MONTGOMERY COUNTY HISTORIC PRESERVATION COMMISSION
STAFF REPORT

Address:	50 Elm Ave., Takoma Park	Meeting Date:	4/8/2026
Resource:	Contributing Resource Takoma Park Historic District	Report Date:	4/1/2026
Applicant:	Tamir Ezzat	Public Notice:	3/25/2026
Review:	HAWP	Tax Credit:	Partial
Case Number:	1148441	Staff:	Dan Bruechert
Proposal:	Retroactive Roof Replacement and Chimney Removal

FIELD REPORT

Inspected Site: 50 Elm Ave. Takoma Park, MD 20912	Purpose of Investigation: Structural review of tree impact TEC #: 25-191FH
Date of Site Visit: 16 July, 2025	Date Report Issued: 25 July, 2025
Report Prepared For: Tamir Ezzat, DDB Workshop	Persons Contacted: Christian Alvez, Insured Connor Sparks, Jenkins Restoration Ali Tolson, Jenkins Restoration

PHOTO 6: DAMAGED ROOF SHEATHING AND RAFTERS

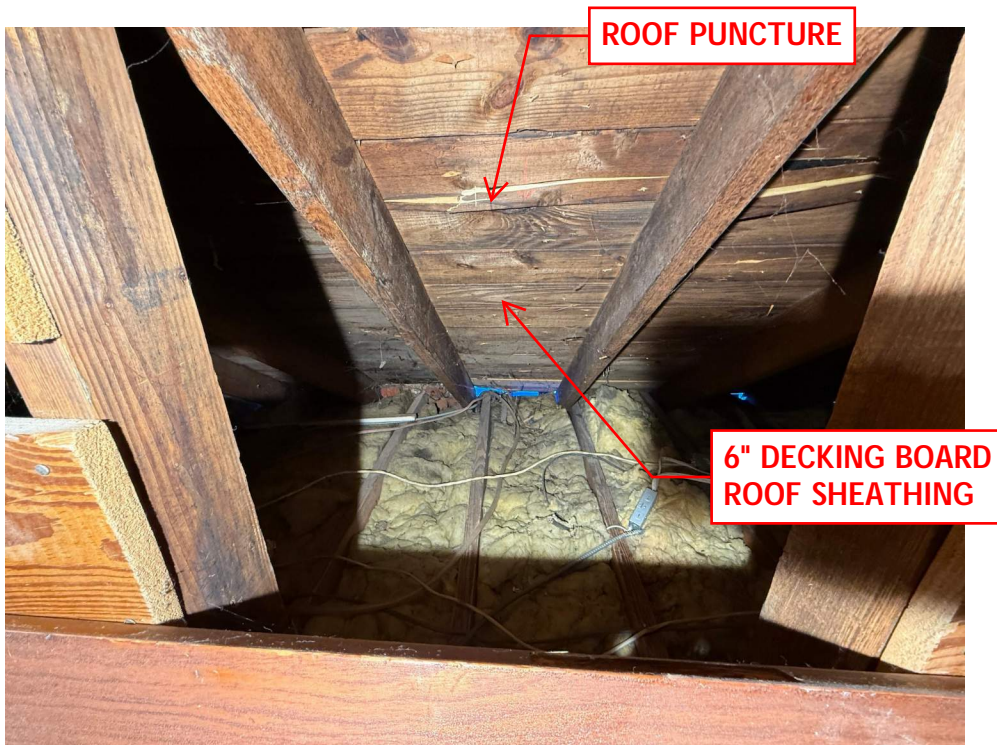
- Punctures are present in the roof sheathing (Appendix A: Photo 6).

- Replace roof sheathing at roof penetrations in full board lengths.
- Replace all missing or damaged rafter tails on the north exterior wall (assume 10% of rafters and roof sheathing are damaged for pricing purposes).

PHOTO 8: DAMAGED WALLS (UNIT 4)

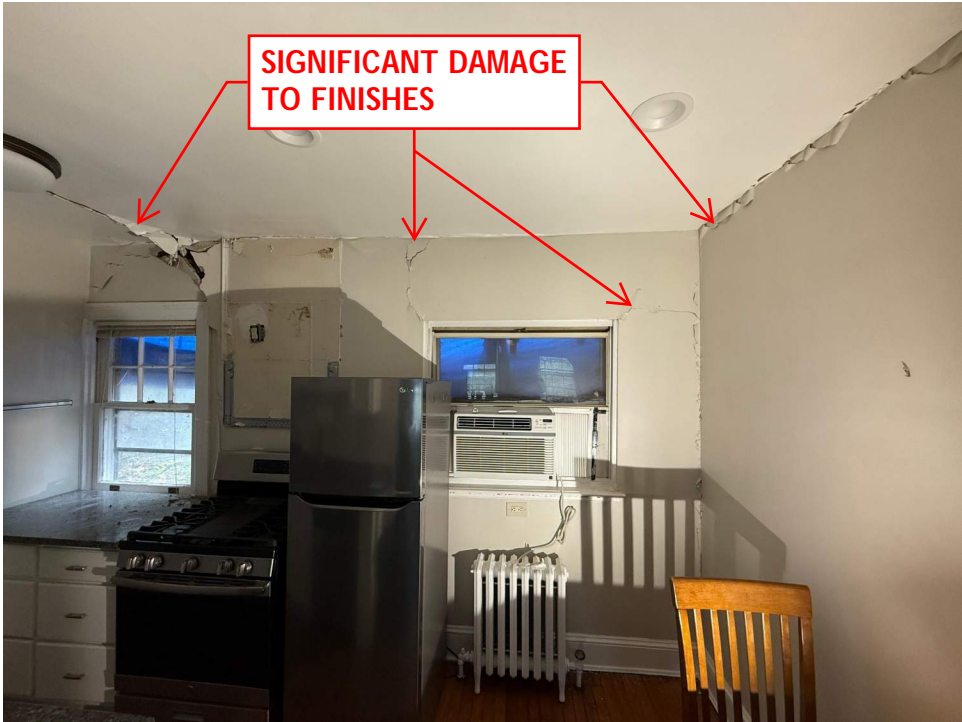
- The North facing exterior wall and adjacent interior walls in the kitchen are compromised, with severe damage to the framing and finishes. Cracks are in the ceiling finishes (Appendix A: Photo 8, 9).
- Hairline cracks are in the finishes throughout the apartment (Appendix A: Photo 10).

PHOTO 18: EXISTING CRACKS IN SOUTH CMU FOUNDATION WALL (BASEMENT)

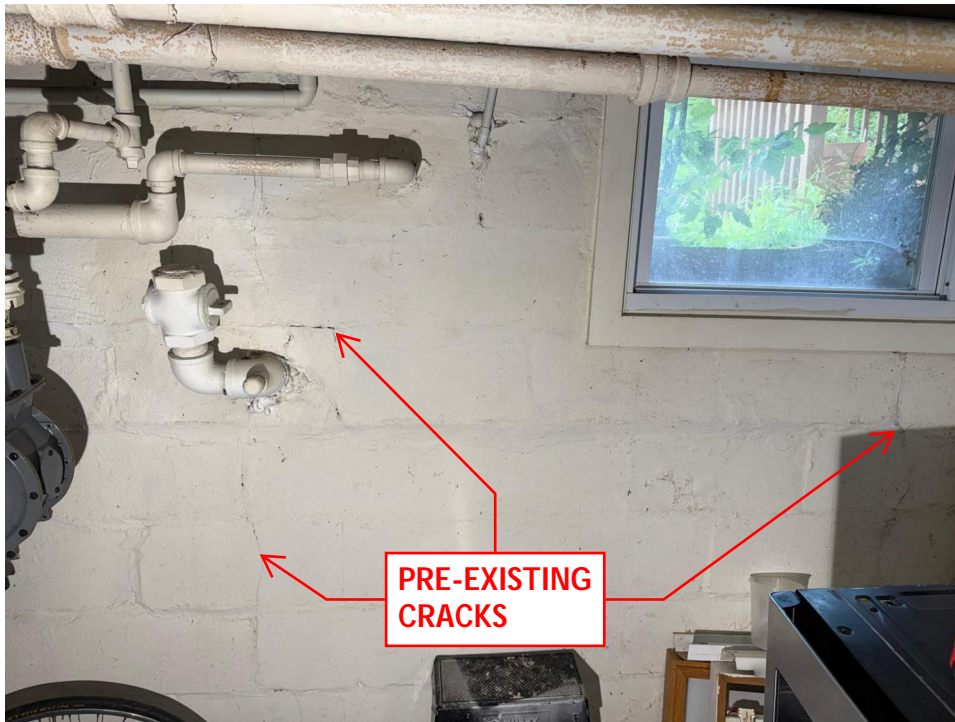
- Cracks related to the impact are in the North facing CMU foundation wall. The wall is displaced and no longer plumb (Appendix A: Photo 17).
- Cracks unrelated to the impact are in the South facing CMU foundation wall (Appendix A: Photo 18).

- Replace cracked and displaced CMU blocks as pointed out by the owner, highlighted in red on the south wall in the basement as shown in the Basement Level Schematic and repoint any damaged or cracked mortar joints (*Appendix B: Figure 3*).
